## Just Like A Boiler

### The Glitch

*Overview:* A customer, who originally agreed to install a zoned radiant floor heating system supplied by a modulating/condensing boiler, changes his mind after the system has been designed. He now wants the system to be supplied by a geothermal heat pump.

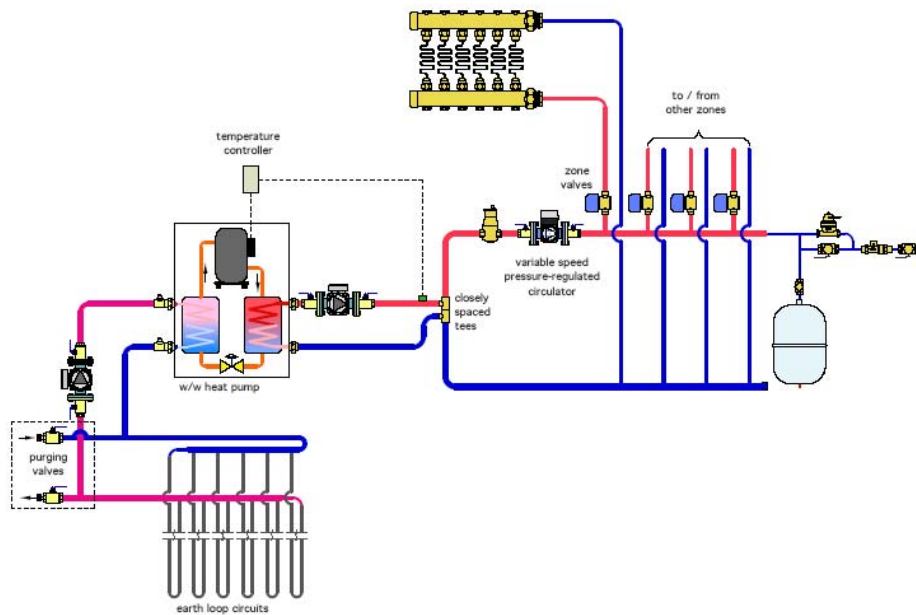
Since the radiant floor system used can operate on low water temperatures, the installer doesn't see this as a big deal. He decides to simply replace the boiler with the water-to-water heat pump using the same closely spaced tee detail as with a mod/con boiler. The piping he installs is shown below.

*Exercise:* Find at least five design omissions or other details that need changing.

One of the big differences between a mod/con boiler and the water-to-water heat pump is that the latter is an “on/off” device. There is no modulation of the heat pump. It’s either full output or nothing. There is also very little water and metal content in the heat exchangers used in a typical water-to-water heat pump. This means there is very little thermal mass to referee between the output of the heat source and the needs of the distribution system. The end result will be short cycling under partial load conditions. The solution is to add a properly sized buffer tank.

- Lack of purging valves on the return side of the zone circuits.
- Lack of adequate valving to purge the earth loop.
- Locating the circulator on the right side of the heat pump such that it “pumps away” from what is typically a high head loss heat exchanger within the heat pump. This placement will encourage cavitation within the circulator.

- The supply temperature sensor providing input to the temperature controller operating the heat source should always be located downstream of the hydraulic separation point — in this case, the closely spaced tees. This allows control of the heat source based on the true supply temperature to the zone circuits.

- The expansion tank connected to the supply header as shown in the glitch drawing forces the distribution circulator to “suck,” rather than push, water through the zone circuits. Again, this sets the stage for cavitation and air removal problems in the distribution system.

- I also recommend an expansion tank on the earth loop circuit to minimize pressure variations over the range of temperatures the earth loop will experience in a typical year.

These omissions/details have been corrected in the drawing below.
